NEW SELECTOR MECHANISM SPARES KIT

TOL NOTICE (US&CAN) – June 27, 2019

TOL Ref. # 11141-SVC

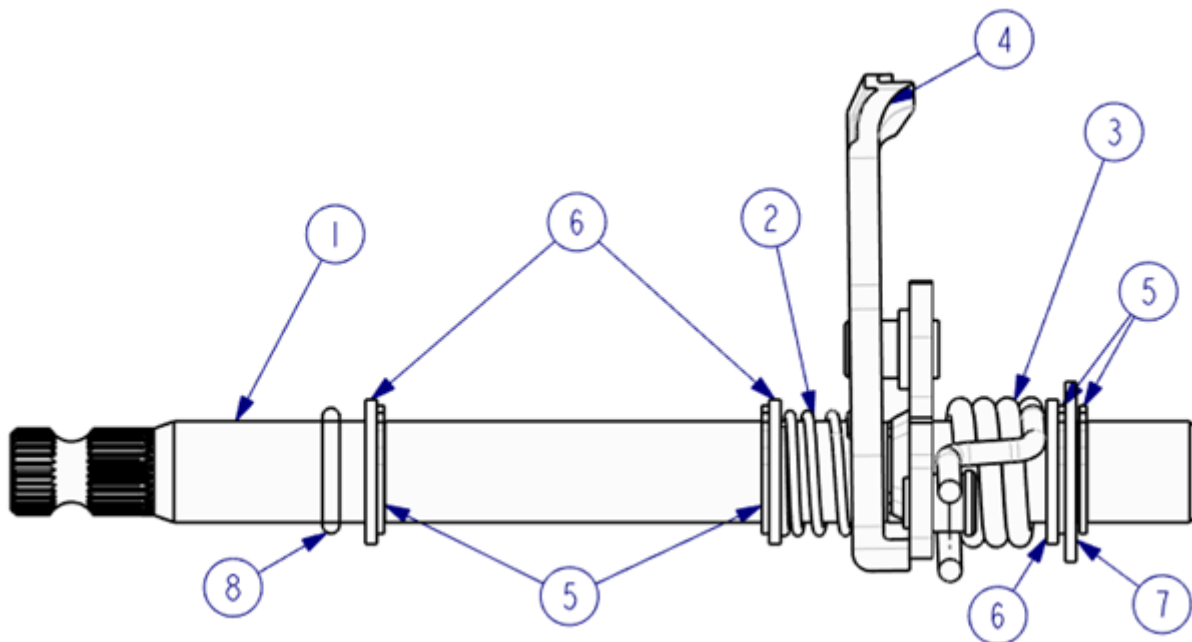
A revised gearchange shaft has been introduced to all liquid-cooled Triumph Modern Classics models. Spares kit **T1191968** has been released for use when replacing the gearchange shaft on all 900cc and 1200cc liquid-cooled twin models.

1. Selector mechanism
2. Pivot plate spring
3. Gearchange return spring
4. Pivot plate
5. Circlip
6. Washer, 14.0 x 20.0 x 1.6
7. Washer, 14.5 x 25 x 1.5
8. O-ring (to be discarded before fitting)

The O-ring (item 8) is fitted for shipping purposes only and must be discarded prior to fitting of the shaft. Installation of the new gearchange shaft is as described in the appropriate Service Manual. Please refer to the Triumph Online EPC dropdown when ordering replacement parts.
